**From:** Rob Tarboton [mailto:rbt@sai.co.za]  
**Sent:** 05 April 2016 06:54 AM  
**To:** Phillipa Harrison  
**Cc:** Pierre Berrange; Alan Fourie  
**Subject:** PROPOSED MOTHER AND CHILD CENTRE: VCC ESTATE

Following the attendance of your display on 18 February 2016 at the VCC that gave some information on the proposed development of the mother and child centre on the estate, I attended a presentation by the developers on 23 March 2016 and have also read the traffic impact assessment (TIA) report for the development.

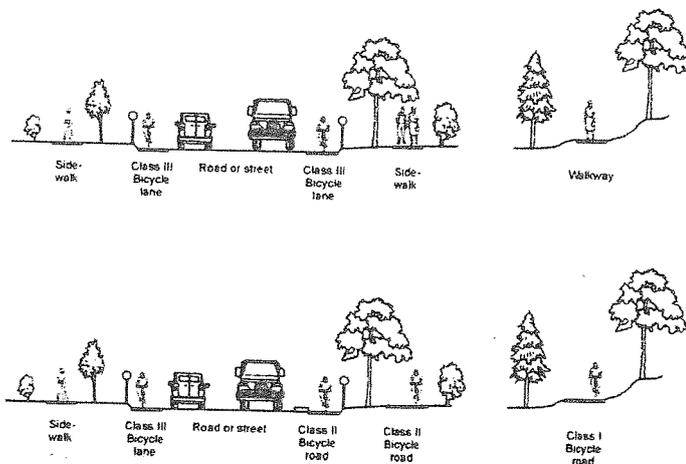
The following road improvements are considered necessary as a minimum in the vicinity of the development:

1. Construct a right turn refuge at the access or accesses into the development area (at the presentation on the development it was mentioned that this would be done, but this is not included in the TIA).
2. Provide off-street facilities for turning and parking public transport vehicles (standard lay-bys will not be adequate).
3. Widen the Peter Brown Drive roadway to provide for two 3 metre wide traffic lanes and surfaced shoulders at least 1 metre wide adjacent to the development boundary (this shoulder is required for the safety of cyclists and this width is narrower than normal guidelines indicate as a requirement).
4. Provide a surfaced foot-walk on one side of Peter Brown Drive from Link Road through to the Ezemvelo entrance gate to separate the runners, walkers and other pedestrians from the vehicular traffic.
